**1099 Osage**

USGBC Review Response

**EAp2:Minimum Energy Performance**

1000006088 [REDACTED] – 1099 Osage  
Review Comments

■ SLincoln Base 07 042011 - Baseline Design (12/15/11 @ 14:25)  
■ SLincoln Prop 042011 - Baseline Design (12/15/11 @ 14:06)

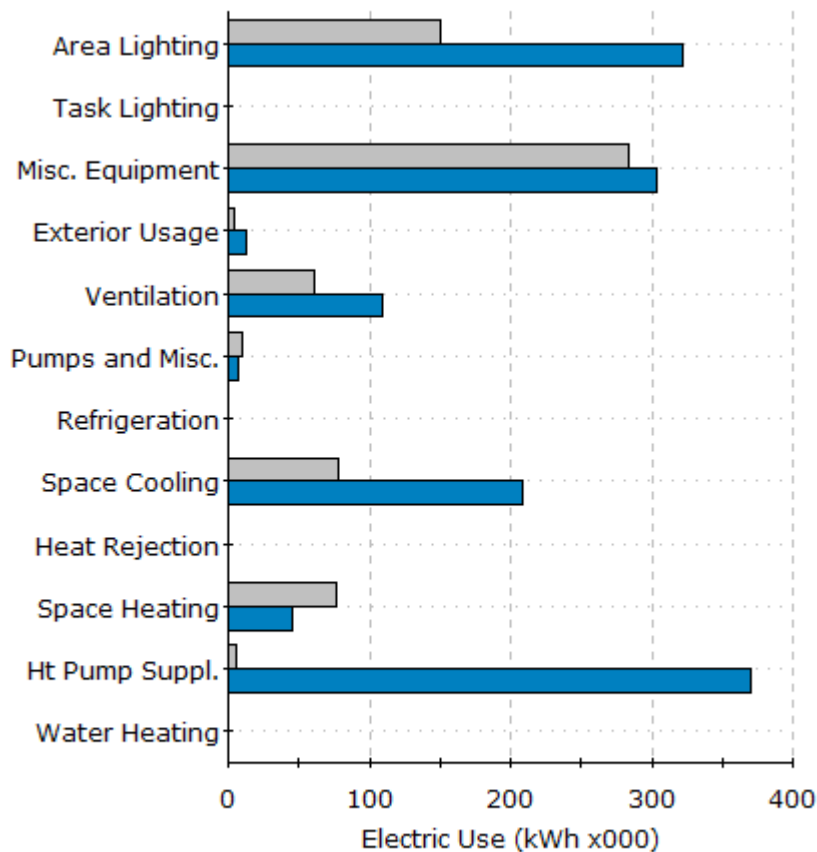
12. The reported heating savings (76.16%) does not appear justified based on the information provided. The similarities between the Baseline and Proposed Case envelope parameters and unitary heating efficiencies make the source of the large savings unclear. While the Proposed Case heating efficiency is expected to be more stable due to water-cooled condensers, the reported information and exceptional calculation indicate the Baseline Case should have a greater fenestration SHGC and a greater internal thermal load profile, both of which tend to reduce winter heating loads. Please review all model inputs and control sequences to verify consistency with design documents and ASHRAE 90.1-2007 Appendix G. If the heating savings remain high, provide a narrative justifying the results. Include references to specific input and output reports to illustrate how the savings were determined.

The significant heating energy savings are mainly due to the elimination of electric resistance supplemental heating in the Proposed design. In [REDACTED] most of our heating loads exist when the OAT is below 40 F. So, the Baseline PTHP system results in a high supplemental heating energy use. The Proposed ground source heat pump system eliminates this load entirely (aside from minor spaces not on the GSHP loop). This is illustrated in the following graph showing Baseline and Proposed electricity use.

Aside from the ground source heat pumps system with high efficiency heat pumps, further heating energy savings are achieved by:

- High performance windows: the low U-factor actually results in significant heating energy savings from the proposed windows relative to the Baseline
- Single zone heat pumps in the common areas compared to PTHP system in the baseline model.
- Energy recovery on the community resource center system.
